# PRELIMINARY PASSIVE HOUSE REPORT

Client: Kristian Wolf  
Project: 2021-KM-02

**Project Address:** 33 Myoora Rd, Terrey Hills NSW 2084

Based on  Design Development drawing set  
Date on plans: 18/08/21  
 Typical U-values for wall build ups

Figure 4 Contextual shading elements allowed for in analysis

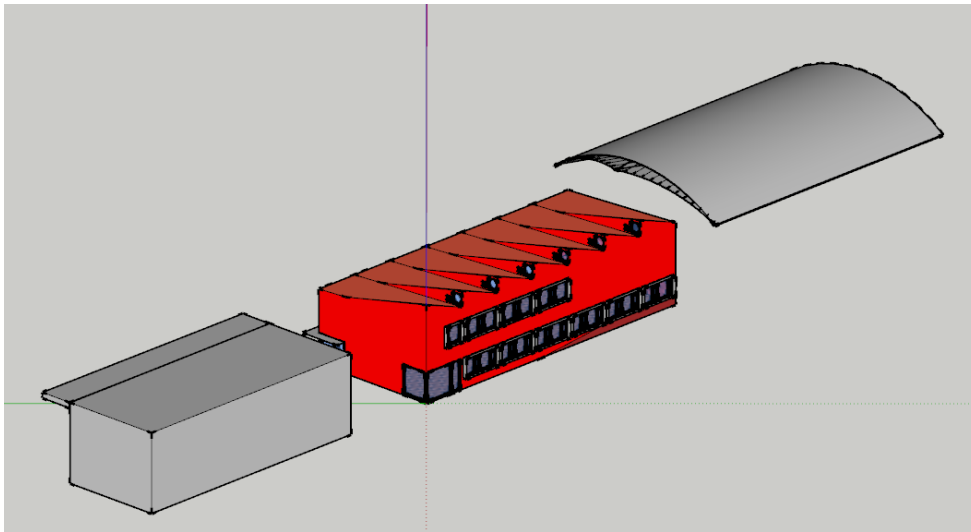
- Note: please use a g-value above 0.25 to maintain the visual light spectrum, except in the case of smart glass or self-tinting
- We have allowed for the adjacent buildings in the shading analysis and louvres to the north-side upper storey windows.
- Note, the Passive House standard may be achieved without additional external shading louvres. This is subject to more detailed information in general.
- For now, we have not allowed for greenery like trees in our modelling
